INSPECTION REPORT OF JOS-MAKURDI 330KV DC OVERHEAD TRANSMISSION LINE

Your letter No NIPP/TRX/2041/2014 dated 28th November, 2014 on the above subject matter refers. Please be informed that the Inspection/Test of Makurdi – Jos 330KV (DC) OHTL with the associated Makurdi 330/132/33KV substation and 330KV line bays extension at Jos was carried out between 8th and 14th December, 2014. The following persons were present for the exercise;

9. Makurdi 330/132/33KV Substation

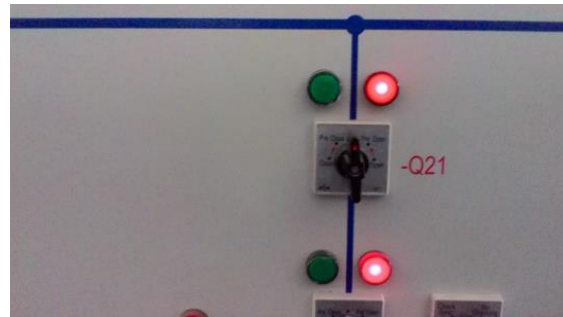
- i. Remote/manual and automatic operations of all isolators and circuit breakers
- ii. Operation of all earthing switches
- iii. Relay injection simulation test to verify differential, overcurrent and earth fault protection schemes were not demonstrated
- iv. Tripping of circuit breakers in response to actuation of Bucholz relay and

transformer
pressure release
valves were not
demonstrated

- i. The contractor should carry out relay injection simulation test to verify differential, overcurrent and earth fault protection schemes in the presence of EMSL engineers
- ii. Likewise, the tripping of circuit breaker in response to actuation of Bucholz relay and transformer pressure release valves
